#### ADDENDUM | 04

Mary C. Howse Elementary School  
641 Boot Road, West Chester, PA 19380  
BHA Job No. 22-114

**DATE OF ISSUANCE:** December 06, 2023

SK-6

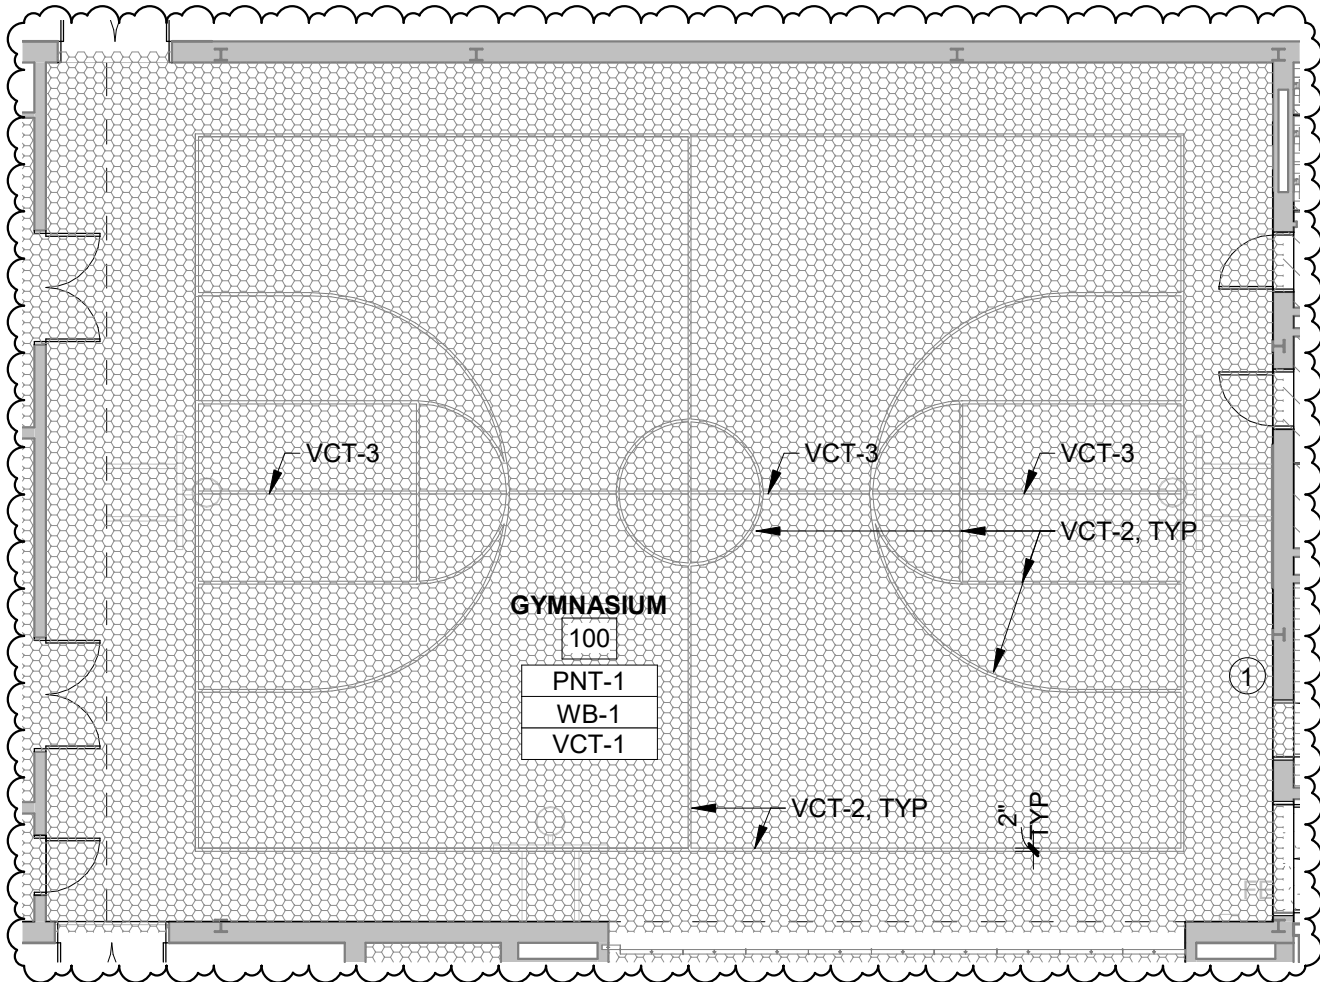
Add new basketball court lines; refer to SK-6.

Add new VCT basketball court lines; refer to SK-6.

③ **ENLARGED PLAN - BOILER ROOM STAIR 2**  
1/4" = 1'-0"

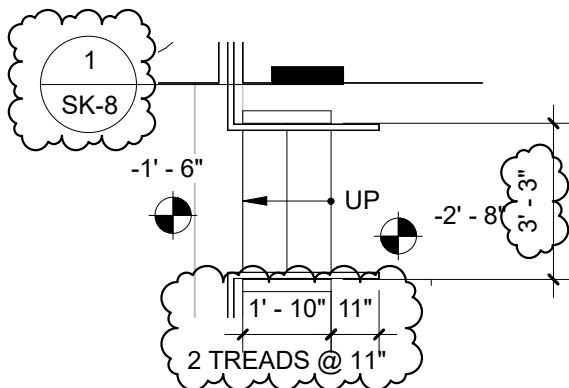
Detail 3 – add stair dimensions; refer to 3/SK-8.

② **ENLARGED PLAN - BOILER ROOM STAIR 1**  
1/4" = 1'-0"

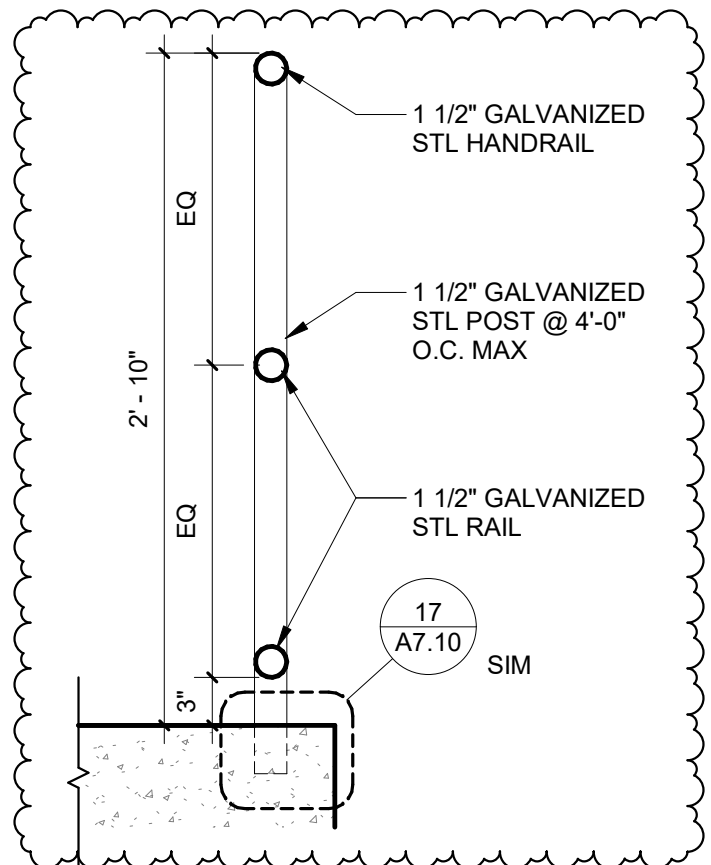
Detail 2 – add stair dimensions; refer to 2/SK-8.
